ADDENDUM TO  
SPECIFICATIONS ENTITLED  
"Humanities Office and Classroom Buildings  
Roof Replacement Project"  
DATED May 2012

**ADDENDUM NO. 2**

**August 2, 2012**

**Addendum No. 2 - Conduit Stand Detail**

① TYPICAL DETAIL AT CONCRETE CONDUIT STAND

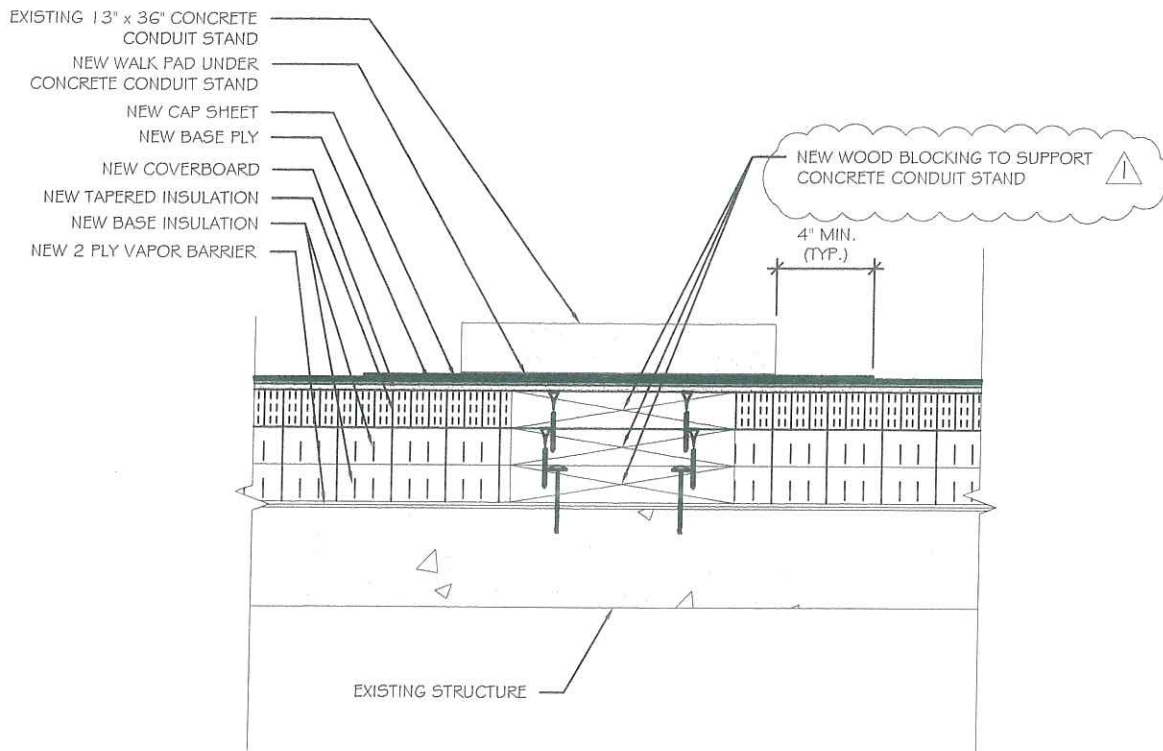
Delete Detail 2 on drawing sheet D3 and replace with the attached new detail.

NOTE: ALL CONCRETE CONDUIT STAND LOCATIONS IDENTIFIED ON SHEET R1 ARE TO HAVE SOLID WOOD BLOCKING INSTALLED UNDER THE TWO PLY MEMBRANE TO SUPPORT CONCRETE CONDUIT STANDS. ATTACH BASE WOOD TO DECK WITH CONCRETE SPIKES (MINIMUM EMBEDMENT 1"). SUBSEQUENT WOOD BLOCKING TO FINISH FLUSH WITH TOP OF INSULATION AND BE ATTACHED WITH EPOXY COATED INSULATION FASTENERS.
